SUBJECT: WOLF CREEK GENERATING STATION - AMENDMENT NO. 63 TO FACILITY
OPERATING LICENSE NO. NPF-42 (TAC NOS. M77395 AND M77471)

The amendment revises Technical Specifications 3/4.4.4 related to power-operated relief valves and 3/4.9.3 related to low temperature overpressure protection. These changes were requested as part of your response to Generic Letter 90-06, "Resolution of Generic Issue 70, 'Power-Operated Relief Valve and Block Valve Reliability,' and Generic Issue 94, 'Additional Low-Temperature Overpressure Protection for Light-Water Reactors,' Pursuant to 10 CFR 50.54(f)."

SAFETY EVALUATION BY THE OFFICE OF NUCLEAR REACTOR REGULATION
RELATED TO AMENDMENT NO.63 TO FACILITY OPERATING LICENSE NO. NPF-42
WOLF CREEK NUCLEAR OPERATING CORPORATION
DOCKET NO. 50-482
WOLF CREEK GENERATING STATION

FIGURE 3.4-4

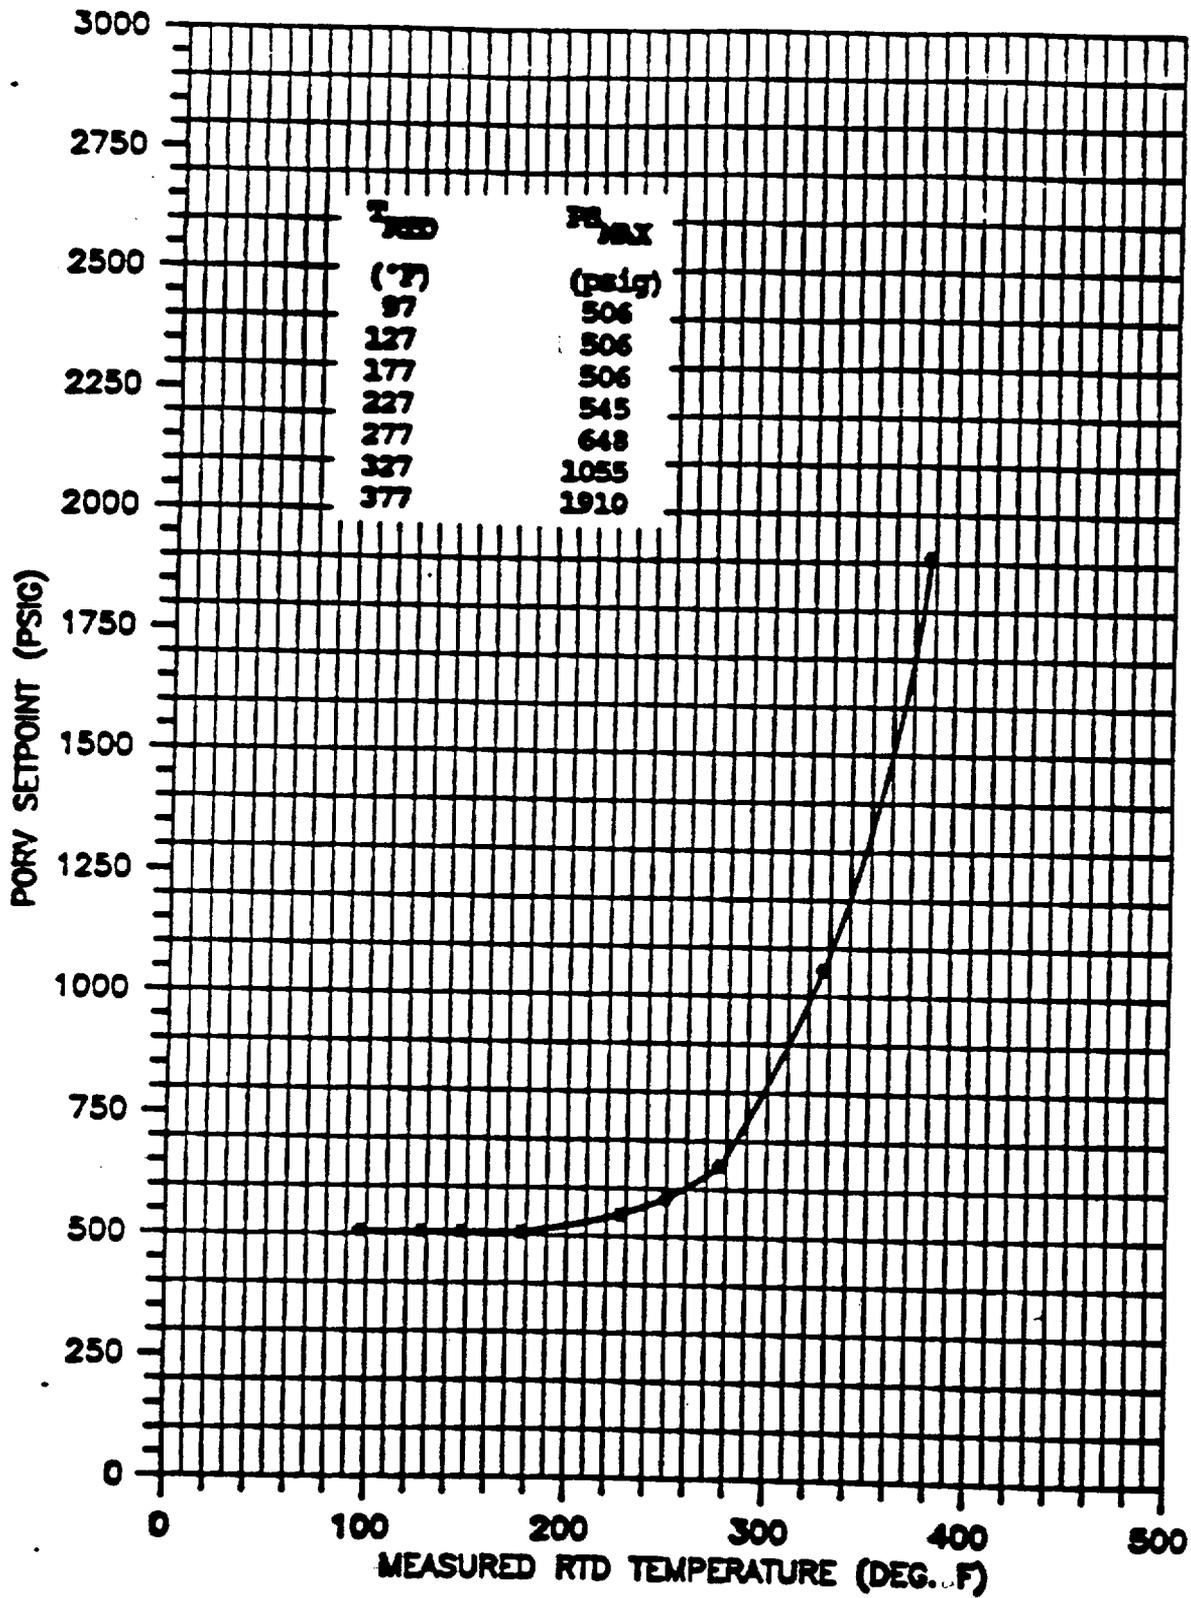
- a. Two residual heat removal (RHR) suction relief valves with Setpoints of 450 psig \pm 3%, or
- b. Two power-operated relief valves (PORV) with Setpoints which do not exceed the limit established in Figure 3.4-4, or
- c. One RHR suction relief valve and one PORV with Setpoints as prescribed above.
